APPLE-1 JUKE-BOX 4 Mbit IMPROVEMENT

v1.09 / v1.09a

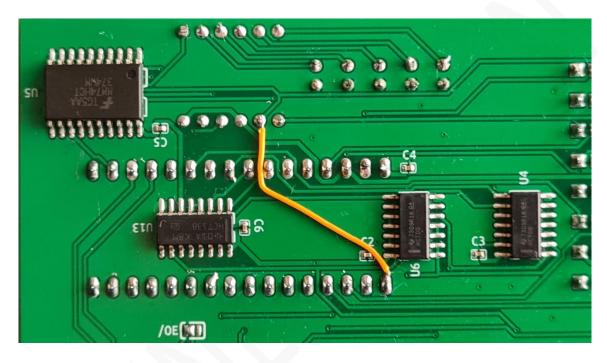
Tuttavia, per rendere la board completamente compatibile con le memorie FLASH della serie **29c040 / 39sf040 da 4 Mbit** è necessario aggiungere il collegamento riportato in figura.

However, to achieve the full compatibility with 4 Mbit FLASH 29c040 / 39sf040, it will be necessary to add the small wiring as shown in the picture above.

Questa modifica è applicabile solo alle board con versione di PCB 1.09 e 1.09a.

Se si utilizzano solamente EPROM/FLASH da 2 Mbit, come quelle fornite di serie (27c020 / 29c020) tale modifica non è necessaria, ma se effettuata non crea problemi di alcun genere.

This modification is intended only for boards with PCB version 1.09 and 1.09a.

If you only use 2 Mbit EPROM/FLASH, such as those originally supplied (27c020 / 29c020), this modification is not necessary. If made, it will be harmless.
